## FINAL UNIT (X45-391x-xx, X45-398x-xx) Schematic diagram

## TX-RX UNIT (X57-785x-xx, X57-861x-xx) Schematic diagram

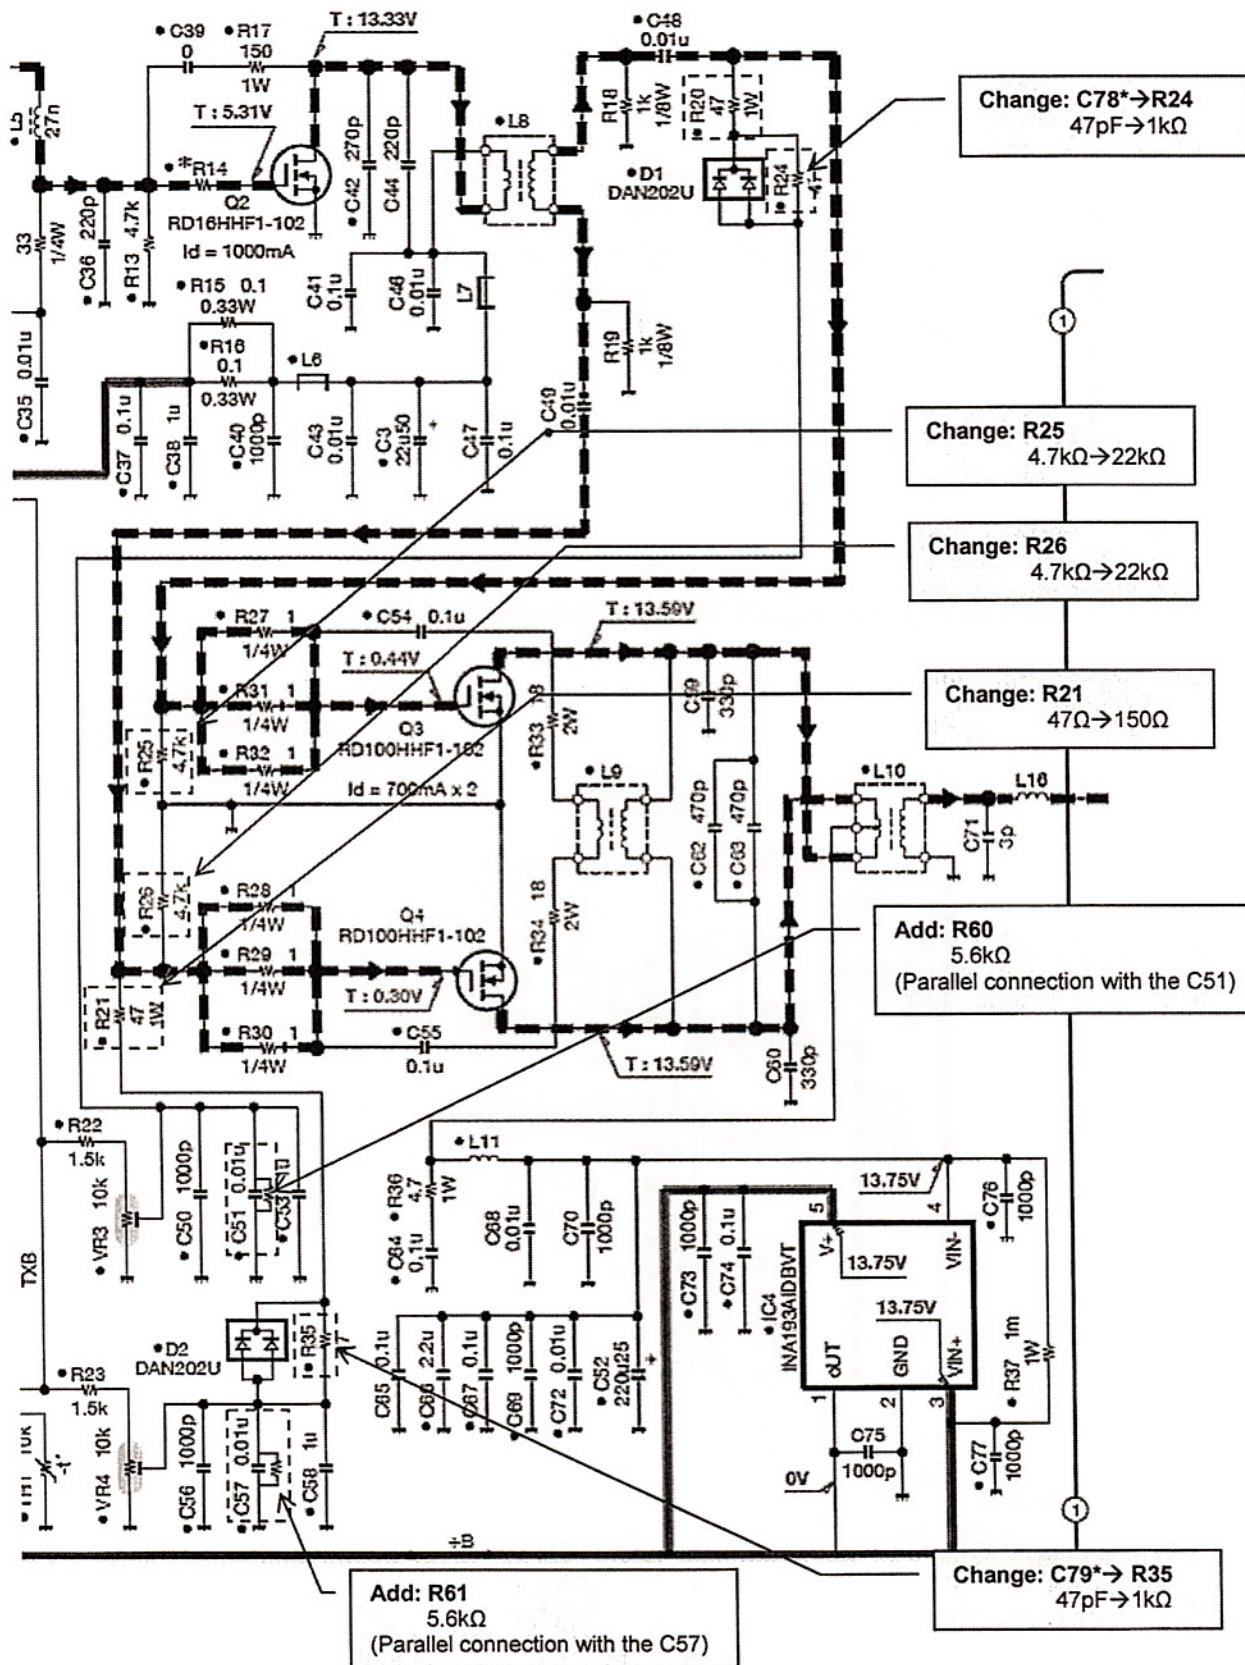
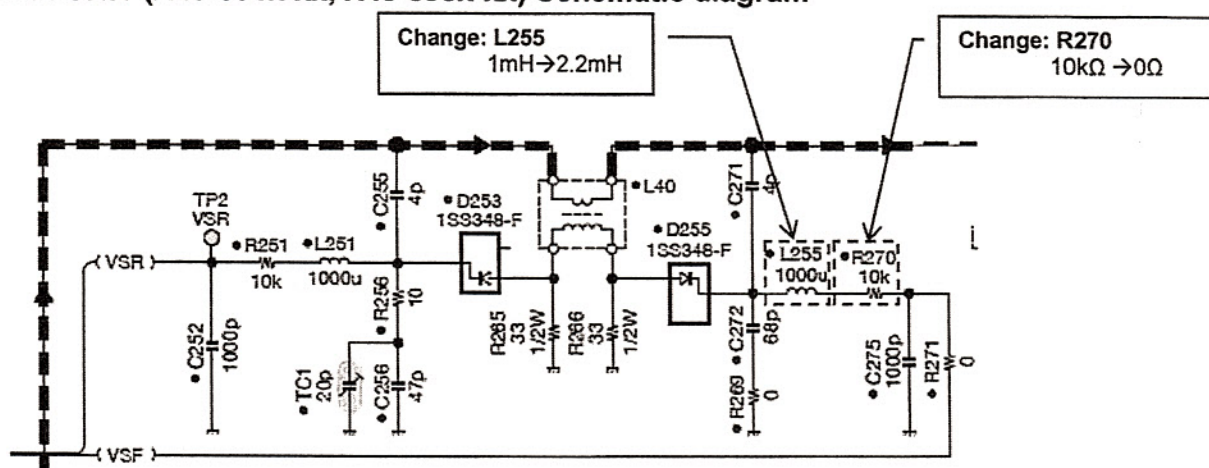
\*In the service manual, 2 x 470Ω (RK73FB2B471J) resistors are listed at the location of R24, R35 instead of the actually mounted C78, C79 (47pF). Please replace these capacitors with 1kΩ resistors.
